Southern California Rapid Transit District  
Metro Rail Project

Analysis of  
Fireproofing Repairs  
to Main Shop Building  
Contract A112  
November 14, 1989

PROTECTION OF FIREPROOFING	JOB No. A-112	SHEET No.
@ GRIDLINE FQ	DESIGNED BY MATHENS	DATE
REPAIR, TYPE IV REFER TO PAR IV(U)	APPROVED

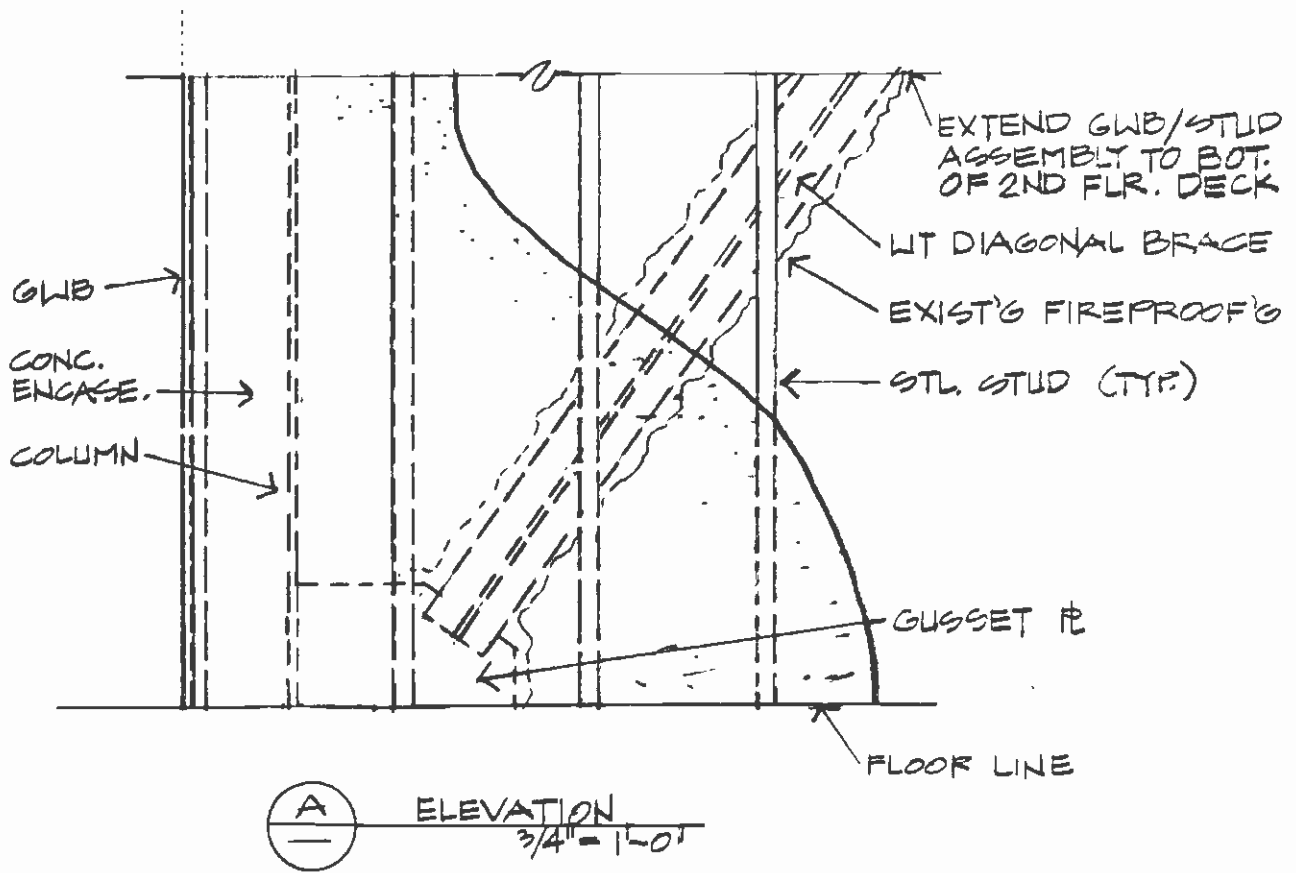
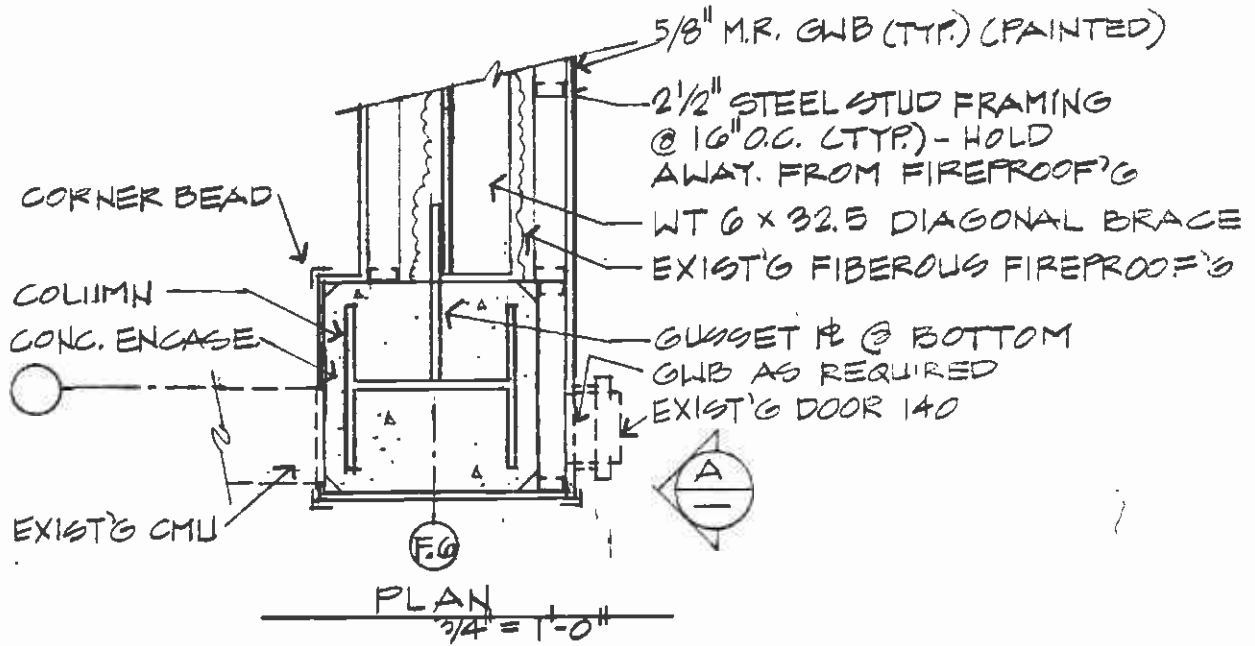
In Systemwide Stores on gridline F.6, remove metal cage from Tool Room No. 131 and construct a full height gypsum board wall and column furring at both sides of K-brace. At the other two locations on gridline F.6, construct similar full-height gypsum board finishes on metal stud furring to totally enclose columns and K-braces. At single columns provide gypsum board finish on metal studs

above concrete encasements to steel deck above. (Repair Type IV.) (Photos Nos. 54, 55, 56, 57, 58, 65, 66, 67, 68, 69, 70, 71.)

PROTECTION OF FIREPROOFING	JOB No. A-112	SHEET No.
	DESIGNED BY MATHEWS	DATE
REPAIR TYPE V refer to paras IV(b, d & g)	APPROVED

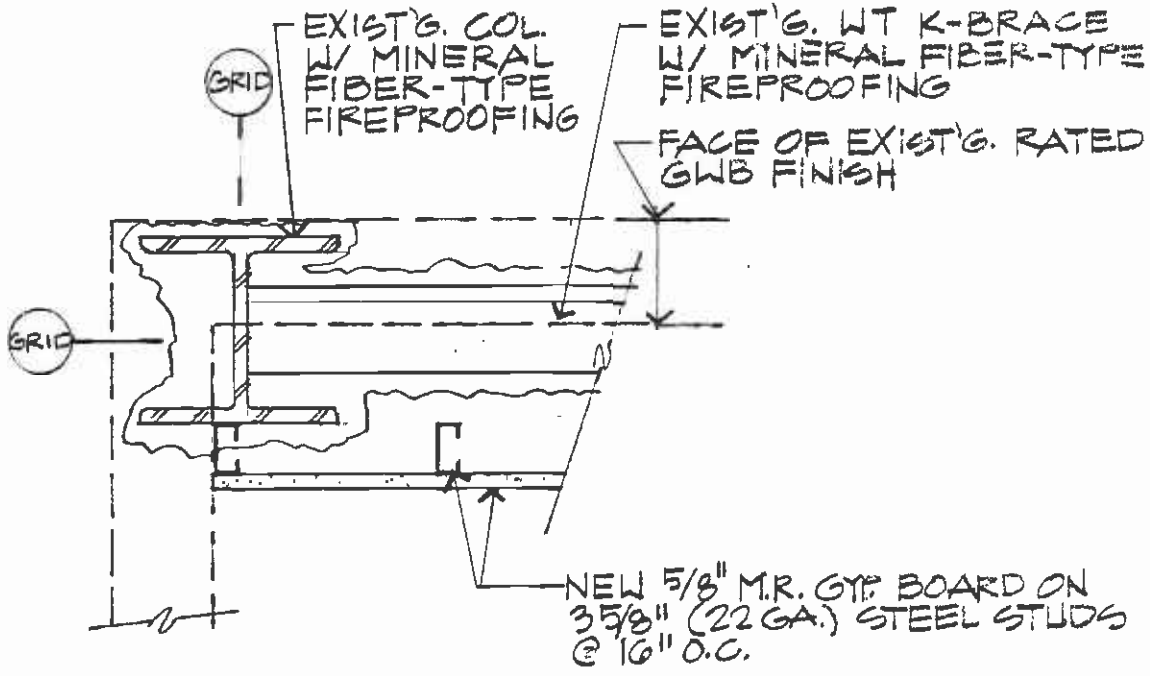
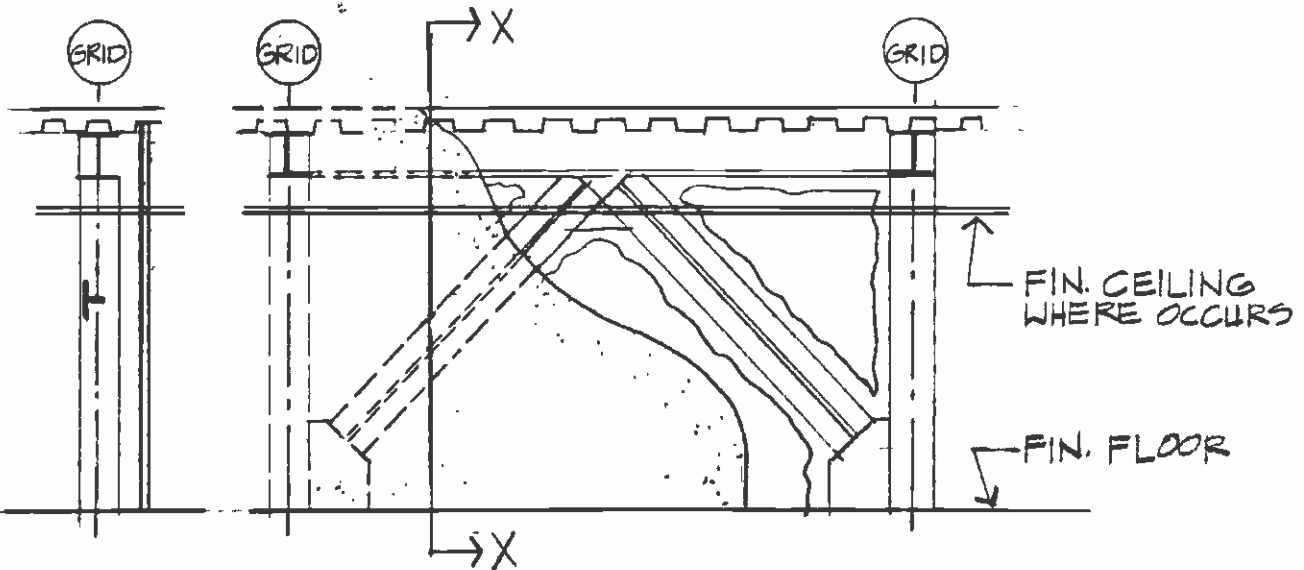
The columns and K-braces on gridline A.7 that project through the existing rated gypsum board wall finish shall have a new full height gypsum board wall constructed in front to enclose the fireproofing. Electrical services and sprinkler test lines shall be extended to the surface of the new wall. (Repair Type V.) (Photos Nos. 5, 6, 7, 8.)

The fireproofing on the columns and the K-braces must be protected by full height gypsum board walls and the steel deck and beams sprayed with a sealer. (Similar to Repair Type V.)

The exposed K-braces must be covered by a new, full height gypsum board wall and existing electrical outlets must be extended to the new finish surface. The existing fireproofing on the steel roof deck and supporting beams must be sprayed with a sealer compatible with the mineral fiber-type fireproofing. (Repair Type V.) (Photos Nos. 21, 22, 23.)
